Submission to Central Precinct rezoning proposal

The City has reviewed the draft Explanation of Intended Effects (EIE), Design Guide, Planning Report, and supporting technical studies. **The City objects to the following aspects of the proposal**, which need to be more fully resolved to position development at Central Precinct for long term success:

Figure 6. The blocks, streets and buildings resemble Barangaroo South

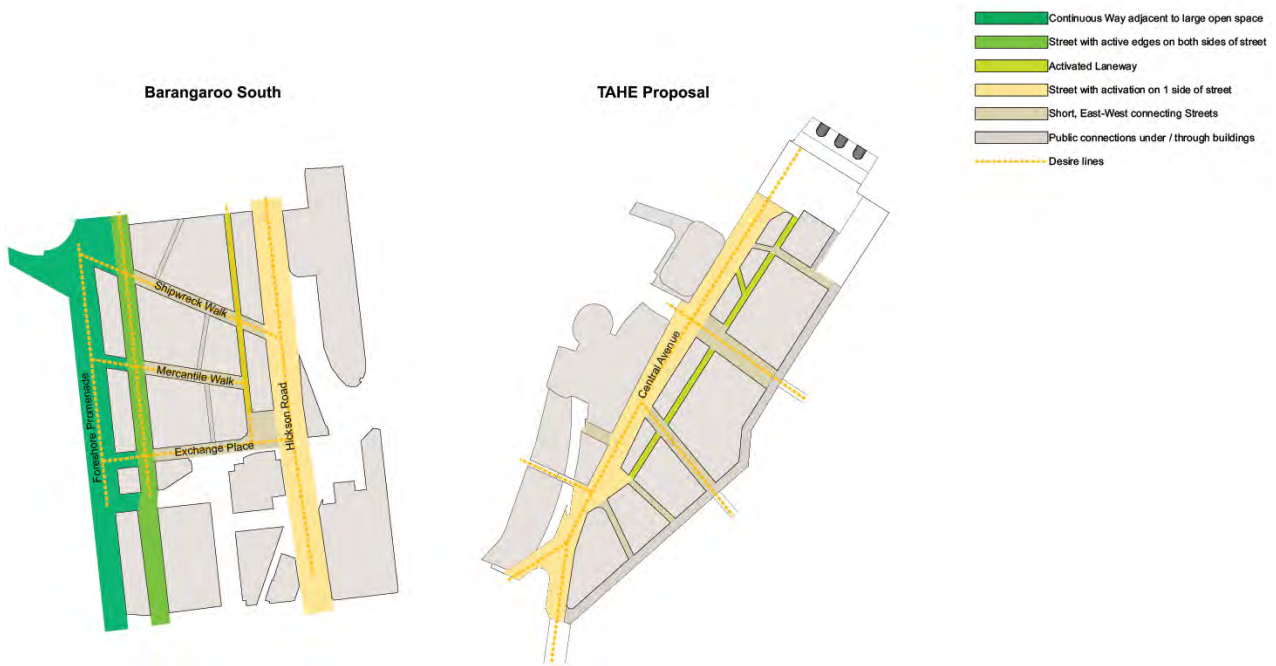
The City notes that the street, block and building layout resembles the shortcomings at Barangaroo South, without the benefit of the foreshore promenade as shown in Figure 7. The majority of the proposal's active edges have been located with poor winter solar access. Building types are not suitable for entertainment, retail and cultural uses.

Figure 10. Sunlight to Mortuary Station Plaza

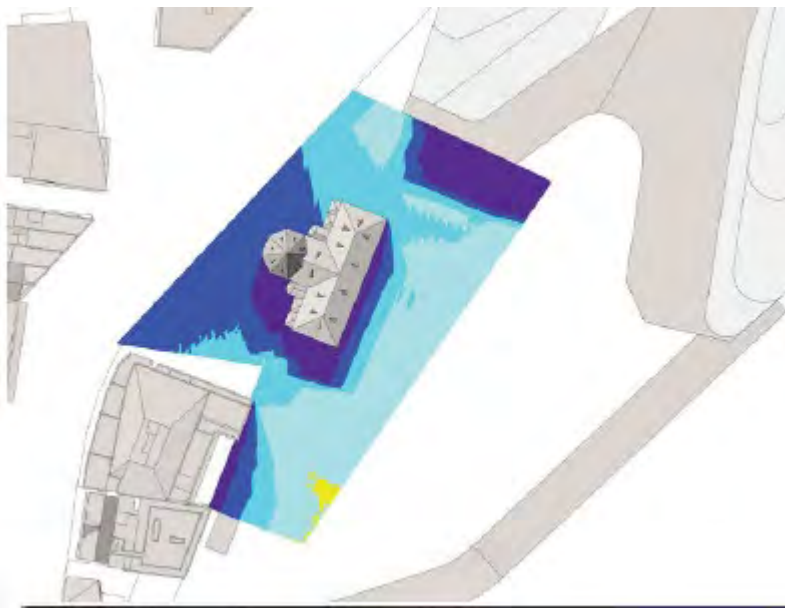
- access from the OSD to the Mortuary station Plaza is awkward
- there is insufficient sunlight for significant tree growth as shown in Figure 10
- the design must accommodate heritage trains into the future.

Figure 13. Poor and convoluted access

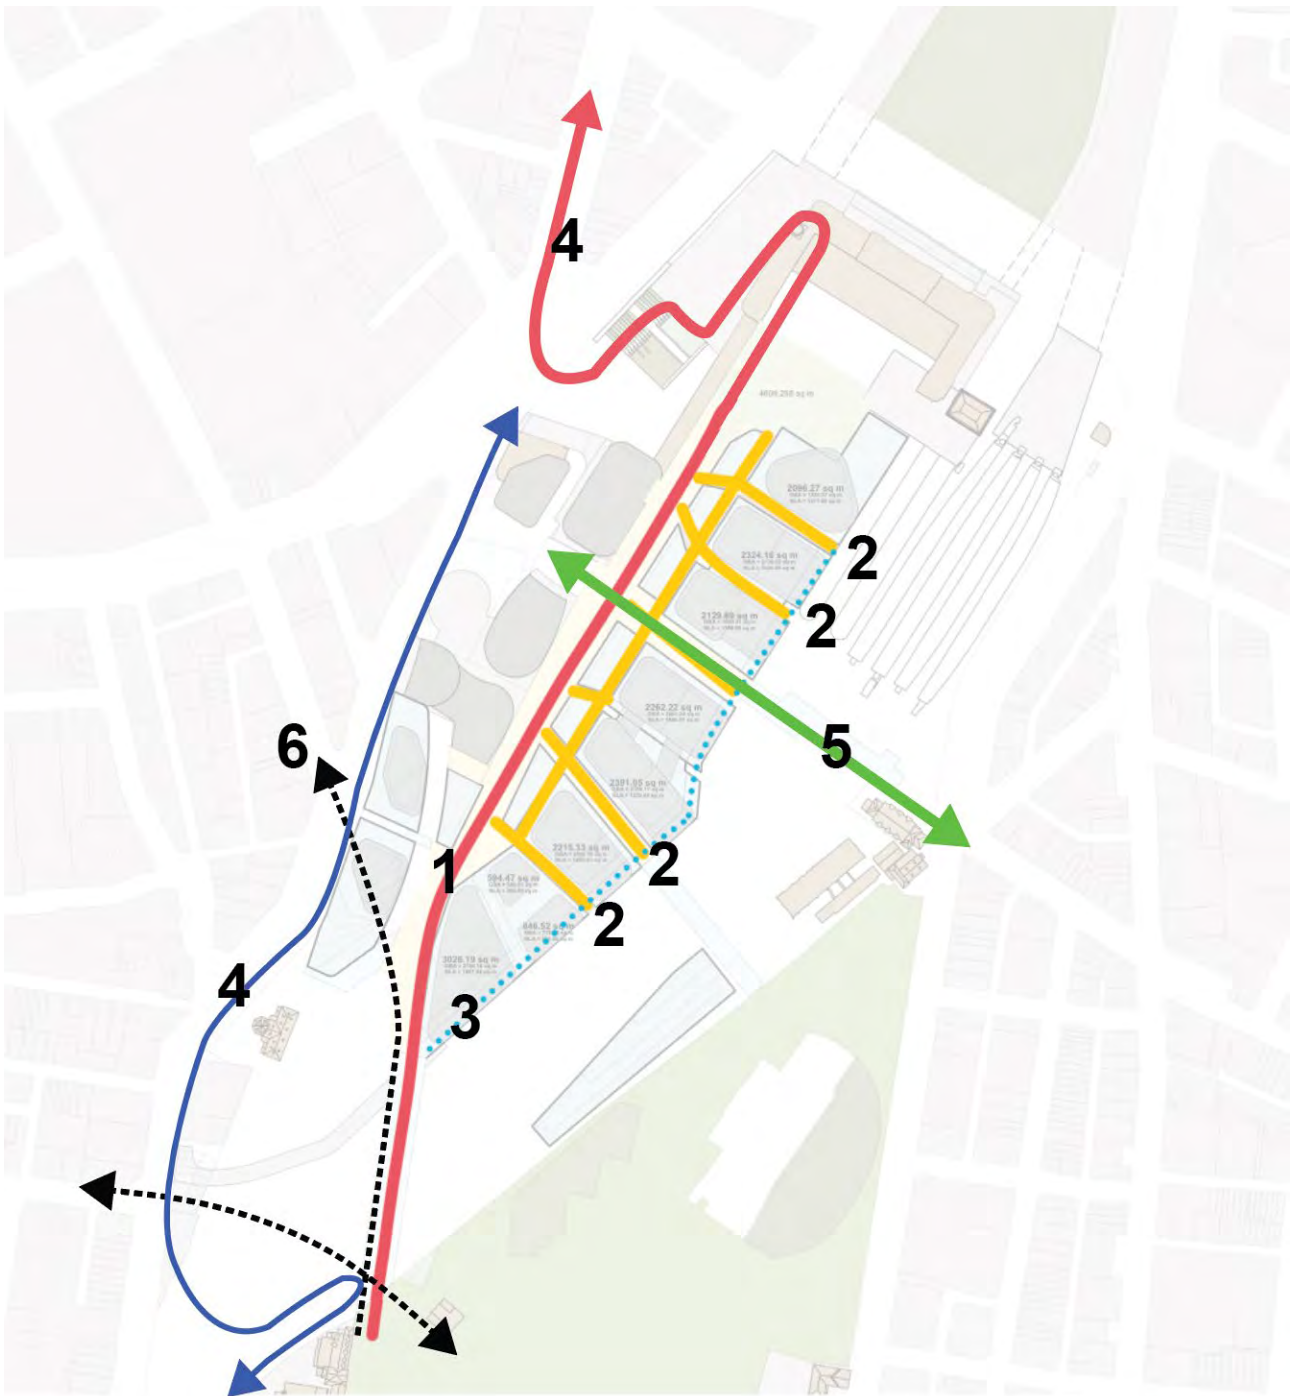
The City recommends reconsideration of the following, illustrated in Figure 14 below:

- Central Ave is too narrow for all parts < 24m (1)
- The east-west streets and lanes lead to dead ends and the lanes are too narrow at 6m (2)
- The eastern arcade has very poor amenity (3)
- The proposed north-south connections are contorted and convoluted (4)
- There is only one clear connection across east west (5)
- At least one more connection is needed, located as per pedestrian movement demand modelling (6)

Figure 15. Eastern colonnade

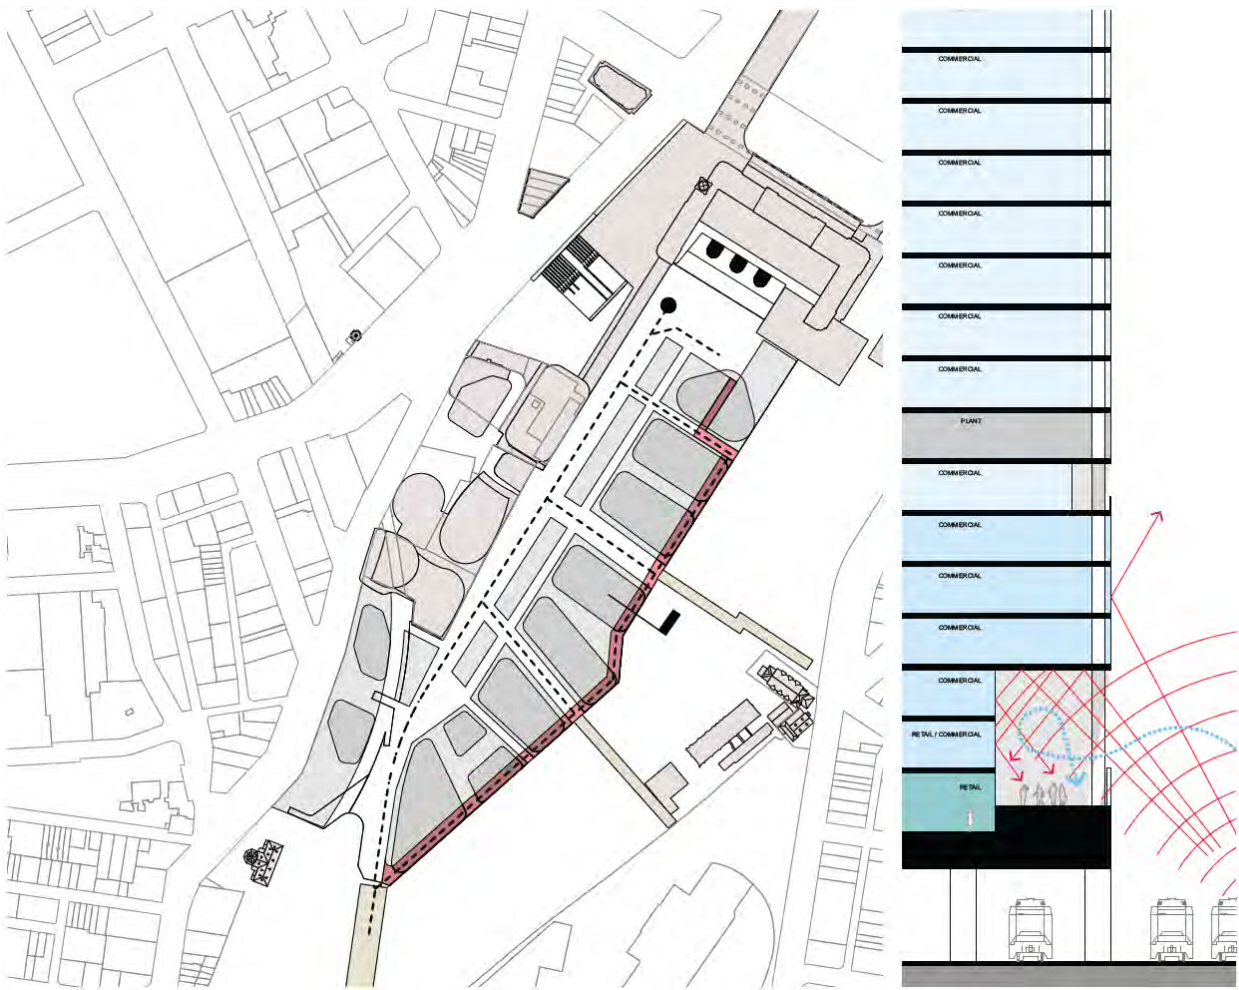
- is fenced and is too narrow for the anticipated users – cyclists accessing hubs, vehicles as shown on diagrams and pedestrians.
- has potential to receive sunlight if open to the sky and shelter from winds
- is disconnected, it is not on any direct path through the precinct or to places within the precinct
- is a poor quality, undercroft space, with no activation, but in the best location for sun and comfortable wind conditions

Figure 23. View of the clock tower from Redfern Station

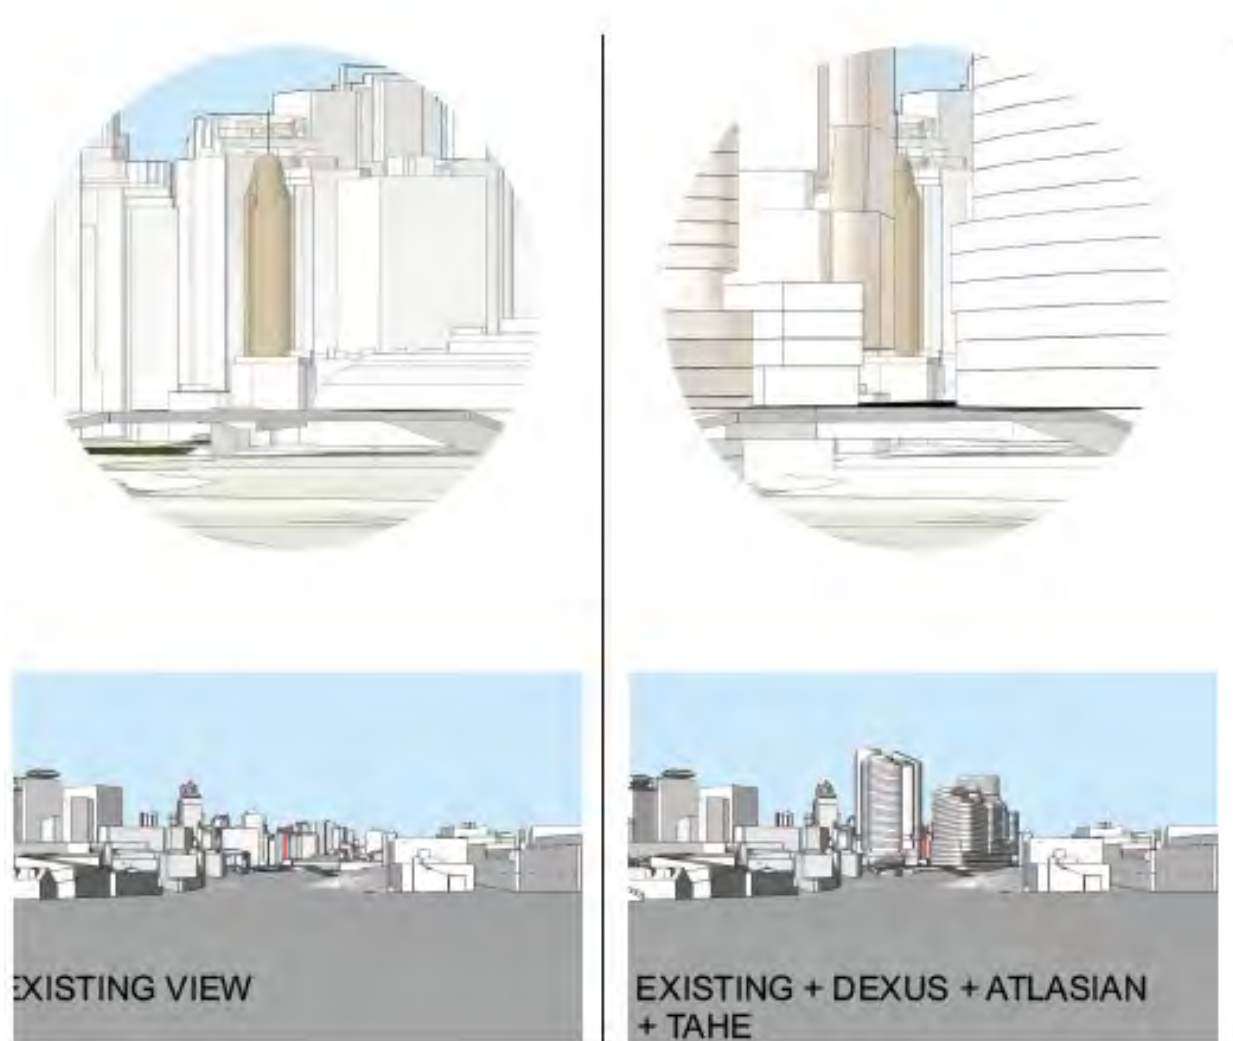
The diagrams above show the significant long views of the clocktower, and the impact of the proposed development on these views, and the view from Prince Alfred Park.
